## **ACTION TRANSMITTAL – 2022-03**

**SUBJECT:** Scope Change Request for Hennepin County CSAH 158 (Vernon Ave) Bridge Replacement

**To:** Metropolitan Council – Transportation Advisory Board (TAB)  
**From:** Jason Staebell, PE – Hennepin County Project Manager  
**Date:** October 20, 2021  
**Re:** CSAH 158 (Vernon Ave) Bridge Replacement Project – Scope Change Request

Figure 1

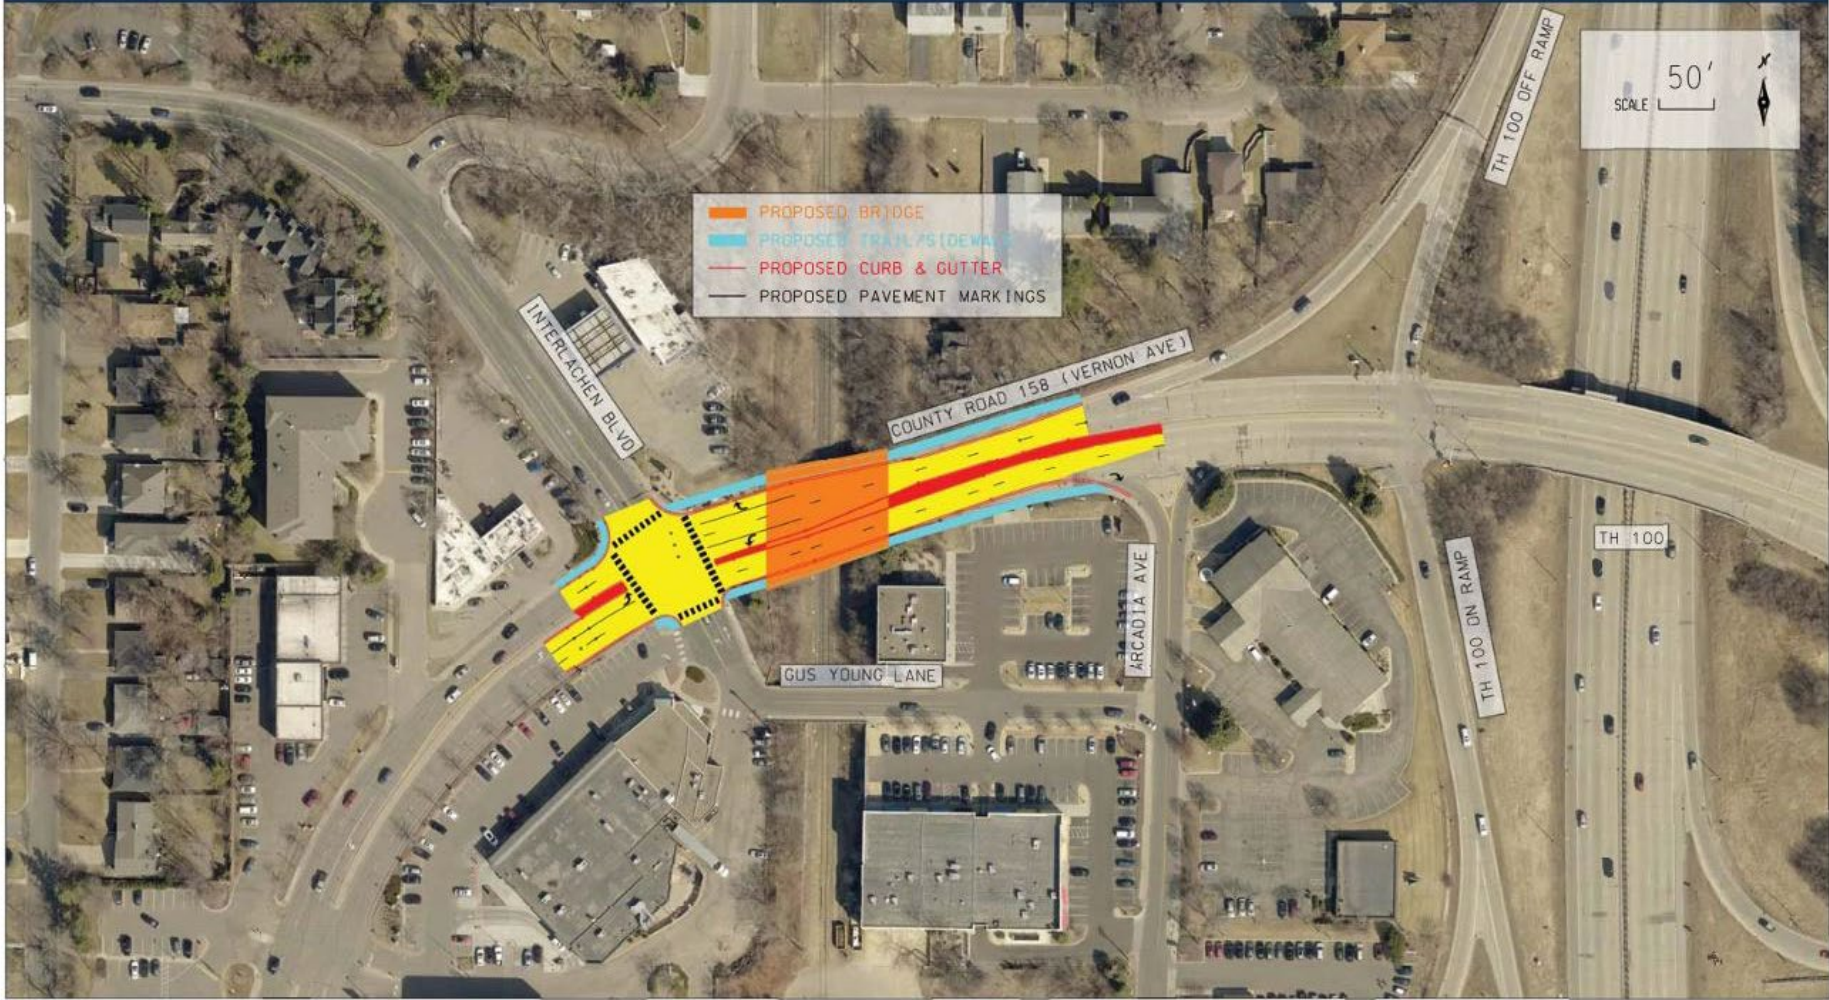
See Figure 1 for layout of expected scope at the time of the 2018 Regional Solicitation Application. See Figure 2 for a layout of the current scope.

Figure 2

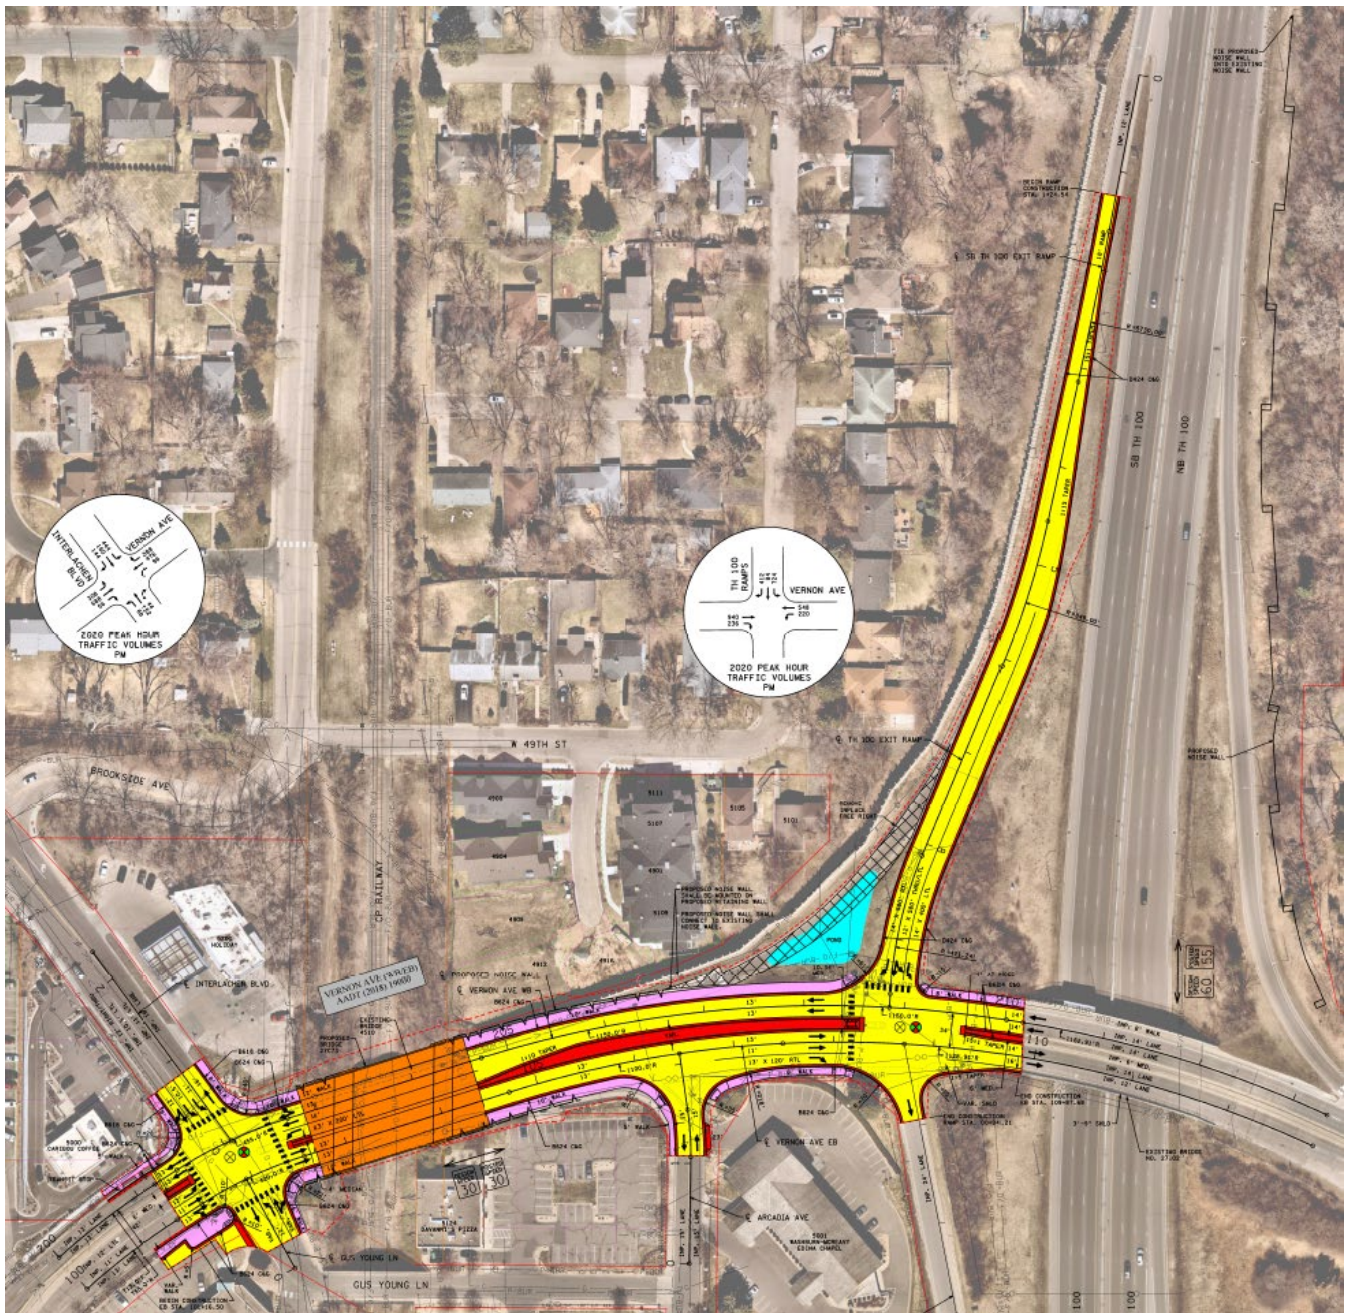
During the preliminary design phase, several design constraints dictated the need for the proposed work shown in Figure 2.

First, profile requirements caused the project to extend to the east. The CP Railway current standards for vertical clearance over their railway required a significant raise in the elevation of proposed Bridge No. 27C73 as compared to the existing 22 foot clearance for Bridge No. 4510. The current preliminary design satisfies the 23 foot minimum vertical clearance requirement over the existing CP railway as well as over a potential future track, which would be located 15 feet east of the existing track (centerline to centerline). The proposed profiles and clearance information can be seen in Figure 3: Vernon Avenue WB and EB Profiles.

On the west side of the project, these proposed profiles were able to tie into the existing roadway at essentially the same location as expected in the 2018 Regional Solicitation Application. However, on the east side of the project, the construction limits needed to extend considerably to the east in order to tie into the built environment. The profile would allow construction to end approximately 26 feet west of the existing bridge over TH 100 (Bridge No. 27102). To be considerate of future maintenance and lifespan concerns, the project was extended this additional 26 feet to match into existing Bridge No. 27102.

Second, the channelized right turn island from the SB TH 100 Exit Ramp is proposed to be removed to address existing safety concerns. Local public agencies have observed two issues with the vehicles traveling along this channelized right turn island: one) excessive speeds, two) poor compliance for the yield condition. In addition, bicycles are known to frequent this area, which presents a higher safety concern since vehicles may complete this turning maneuver at a relatively high rate of speed.

Third, roughly 825 feet of the SB TH 100 Exit Ramp is proposed to be reconstructed in order to accommodate longer left and right dedicated turn lanes. MnDOT required traffic modeling of the SB TH 100 exit ramp to determine if vehicles would queue onto the freeway in the build condition or in the 20 year future condition. It was found that while queuing was not expected to reach the freeway with build year volumes, the same could not be said for the 20 year future condition. Thus, MnDOT requires that the ramp be updated to accommodate the future condition.

The turn lane extension required reconstruction of the ramp beyond the extents of the proposed turn lanes to reduce the likelihood of retaining walls. The ramp is proposed to be re-aligned as close to the existing noise wall as possible while still maintaining the recommended 10 feet of clear distance for snow storage. This realignment allows the slopes between the ramp and TH 100 to be moderate enough that retaining walls (and guardrail) will not be required. Retaining walls are not desired because they present safety, maintenance, and cost implications.

Fourth, a noise wall is proposed on the east side of TH 100 due to the "Noise Requirements for MnDOT and other Type I Federal-aid Projects" effective since July 10, 2017. These requirements state, "*The noise analysis must include all areas that are affected by the project, including impacts from the project that occur beyond the official project limits/termini.*" and that ". . . *the analyst should extend the modeling limits at a minimum 500' or to a 'logical' termini point greater than 500' from the end of physical construction.*"

Fifth, the right turn lane along westbound Vernon Ave at Interlachen Blvd that was proposed in the 2018 Regional Solicitation Application was removed from the scope of the project. After extensive modeling of the project area, it was found that the benefits of right turn lane were not justified. The right turn lane would reduce vehicle delay at the intersection, however the reduction was relatively modest, especially in comparison to the improvement provided by the left turn lane. The four lane section is relatively uninviting and uncomfortable for people walking in the area, requiring a longer crossing time. A three lane section was determined to provide a better balance of needs between people walking and people driving. Overall, the removal of the right turn lane may be viewed as a modest reduction in benefits for people driving, however, a significant increase in benefits for people walking.

**Figure 4:** Noise Study Required Extents (500' radius)

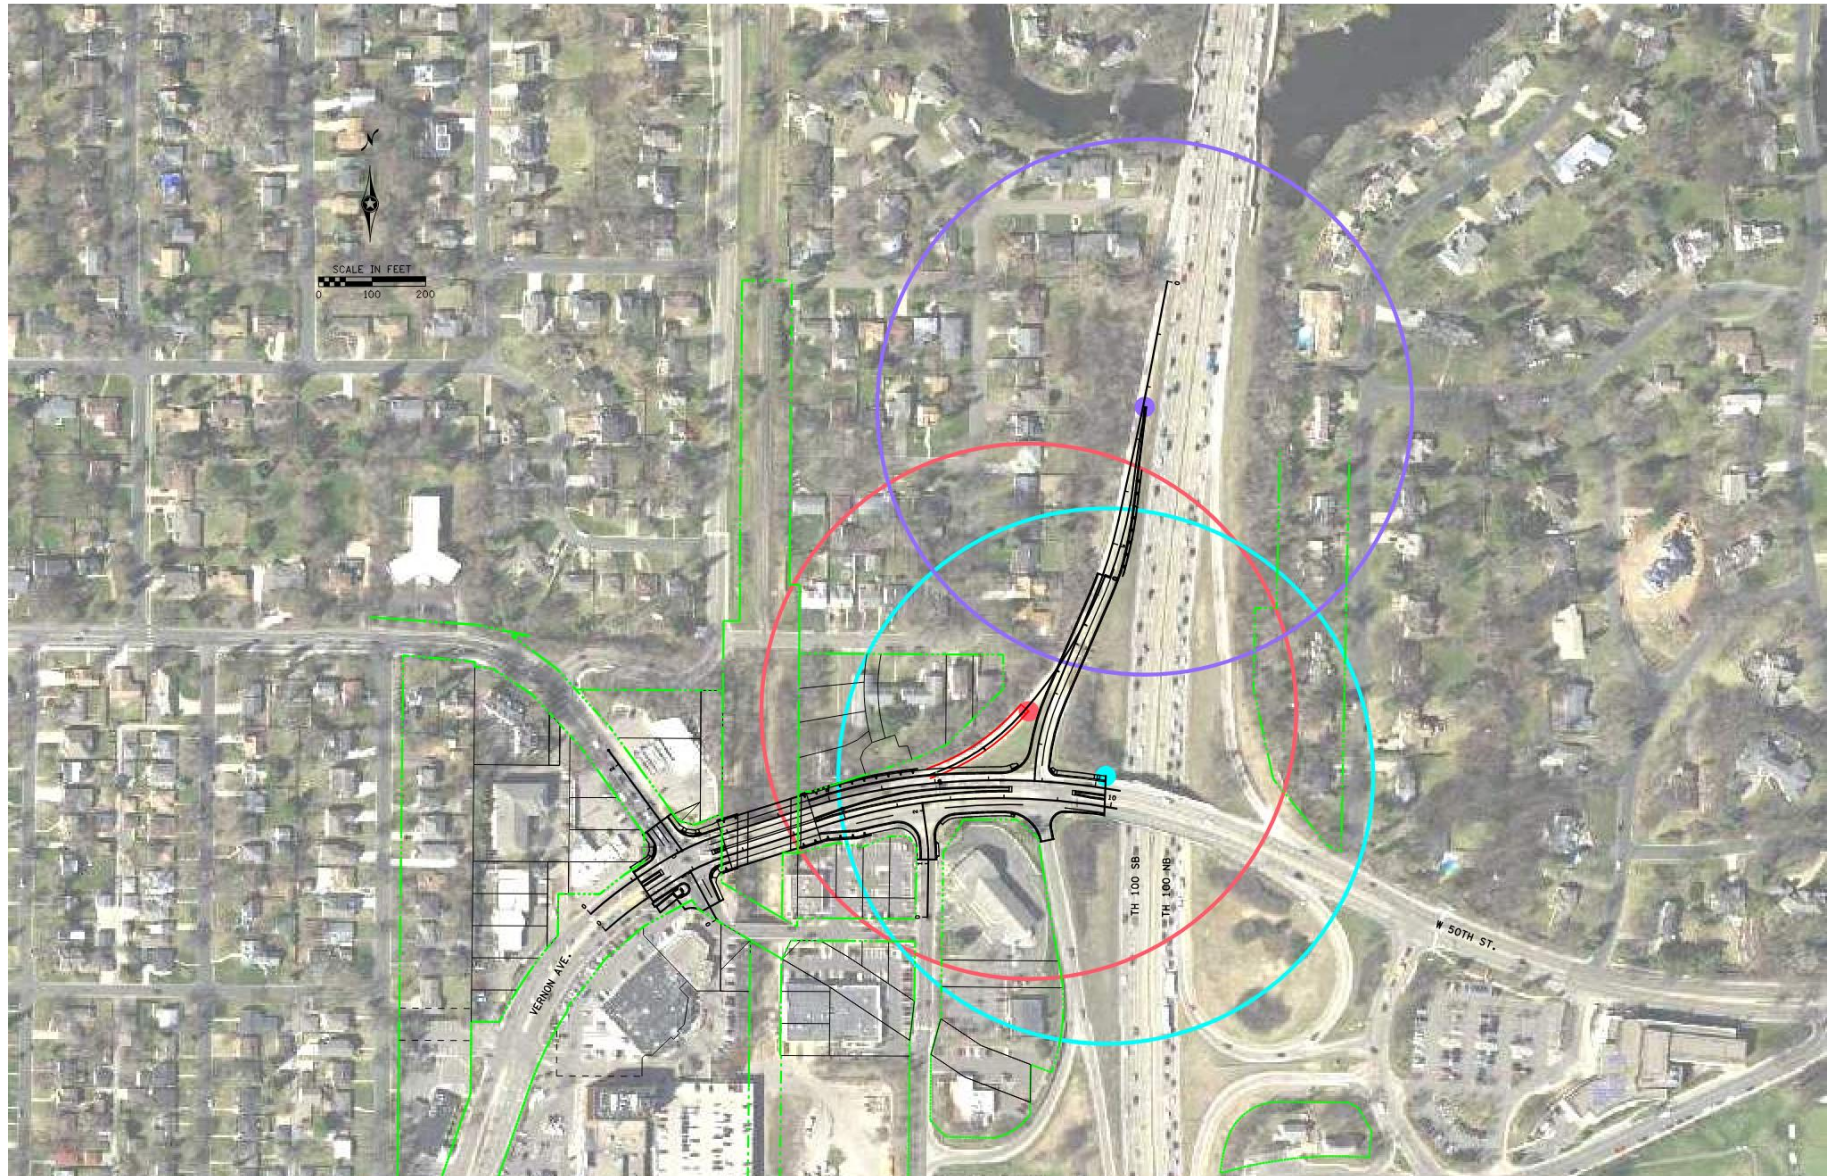
Figure 4 shows the extents of a 500 foot radius from three points, one) the edge of WB Vernon Avenue Construction, two) the edge of construction if the channelized right turn island was reconstructed, and three) the edge of reconstruction of the ramp.

As seen in Figure 4, even disregarding any construction on the SB TH 100 Exit Ramp or channelized right turn island, the noise study would be required to consider the homes just east of TH 100 based solely on the construction of WB Vernon Avenue. Those homes are within 500 feet of the proposed construction.
